Informal document GRE-75-04  
(75th GRE, 5-8 April 2016,  
agenda item 4)

**Modifications to Annex 3 of the draft Resolution on the  
common specification of light source categories  
(ECE/TRANS/WP.29/GRE/2015/28)**

## Annex 3

Figure 1\*

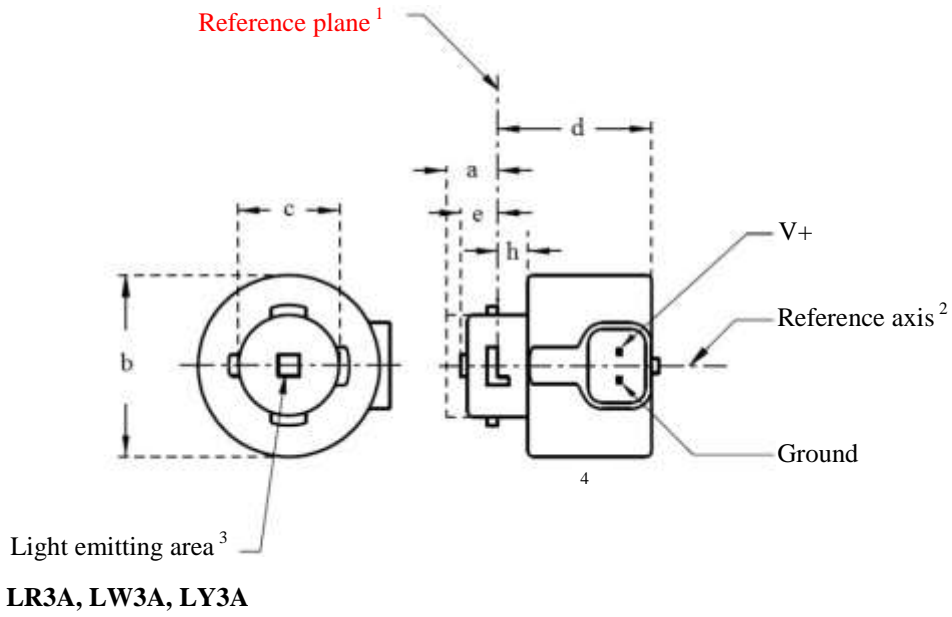
For the notes see sheet L3/2.

Dimensions		Production LED light sources	Standard LED light sources	
a	mm	6.0 max.		
b	mm	c + 10.0 min. 38.0 max.		
c	mm	18.5 ± 0.1		
d	mm	28.0 max.		
e <sup>13/</sup>	mm	3.0 ± 0.30	3.0 ± 0.15	
h	mm	5.5 + 0.0/ - 0.1		
Cap	LR3A, LR3B LW3A, LW3B LY3A, LY3B	PGJ18.5d-1 PGJ18.5d-24 PGJ18.5d-15	in accordance with IEC Publication 60061 (sheet 7004-185-1)	
<i>Electrical and photometric characteristics</i>				
Rated values	Volts		12	
	Watts	LR3A, LR3B	3	
Objective Values <sup>8</sup>	Watts (at 13.5 V DC)	LW3A, LW3B LY3A, LY3B	4	
		LR3A, LR3B	3.5 max.	
		LW3A, LW3B LY3A, LY3B	5 max.	
	Luminous flux (in lm at 13.5 V DC)	LR3A, LR3B	80 ± 20% <sup>9</sup>	80 ± 10% <sup>10</sup>
		LW3A, LW3B	250 ± 20%	250 ± 10% <sup>11</sup>
		LY3A, LY3B	150 ± 20% <sup>9</sup>	150 ± 10% <sup>10</sup>
Luminous flux (in lm at 9 V DC)	LR3A, LR3B	19 min		
	LW3A, LW3B	50 min.		
	LY3A, LY3B	30 min

Figure 1\*  
Main Drawing

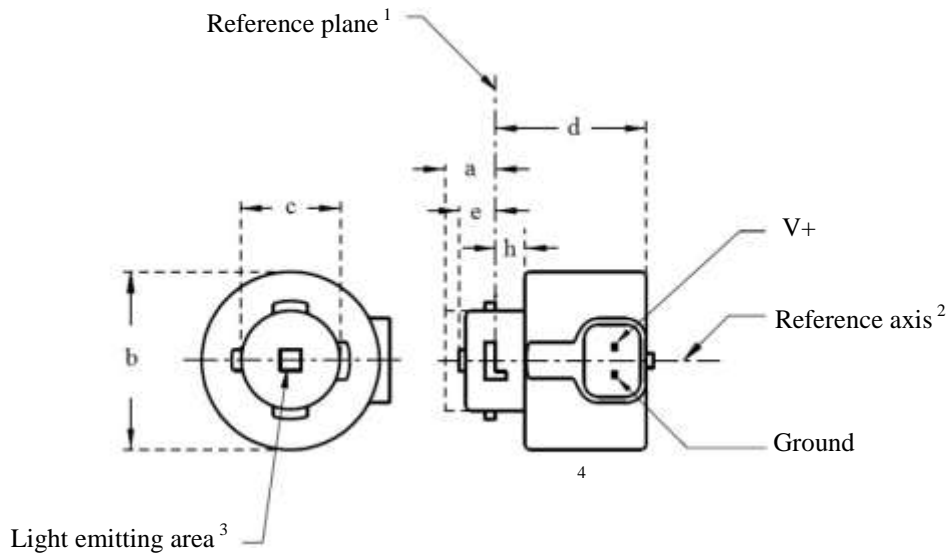
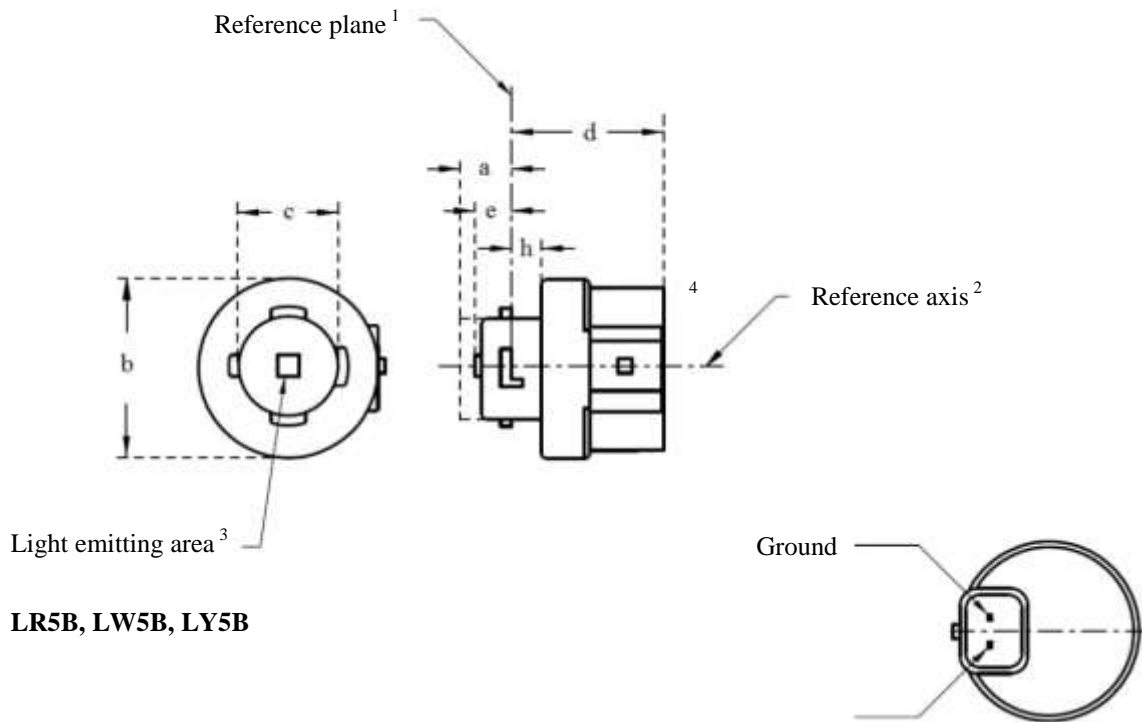
LR5A, LW5A, LY5A

LR5B, LW5B, LY5B

For the notes see sheet L5/2

Dimensions		Production LED light sources	Standard LED light sources	
a	mm	6.0 max.		
b	mm	c + 10.0 min. 38.0 max.		
c	mm	18.5 ± 0.1		
d	mm	28.0 max.		
e <sup>11/</sup>	mm	3.0 ± 0.30	3.0 ± 0.15	
h	mm	5.5 + 0.0/ - 0.1		
Cap	LR5A, LR5B LW5A, LW5B LY5A, LY5B	PGJ18.5d-10 PGJ18.5d-28 PGJ18.5d-19	in accordance with IEC Publication 60061 (sheet 7004-185-1)	
<i>Electrical and photometric characteristics</i>				
Rated values	Volts		12	
	Watts	LR5A, LR5B	3	
		LW5A, LW5B LY5A, LY5B	6	
Objective Values <sup>8</sup>	Watts (at 13.5 V DC)	LR5A, LR5B	3.5 max.	
		LW5A, LW5B	8 max.	
		<sup>10</sup> LY5A, LY5B		
	Luminous flux (in lm at 13.5 V DC)	<sup>5</sup> LR5A, LR5B	120 ± 15%	120 ± 5% <sup>9</sup>
		<sup>6</sup> LW5A, LW5B	350 ± 20%	350 ± 10% <sup>9</sup>
		<sup>7, 10</sup> LY5A, LY5B	280 ± 20%	280 ± 10% <sup>9</sup>
	Luminous flux (in lm at 9 V DC)	<sup>5</sup> LR5A, LR5B	28 min.	
<sup>6</sup> LW5A, LW5B		65 min.		
<sup>7, 10</sup> LY5A, LY5B		55 min.
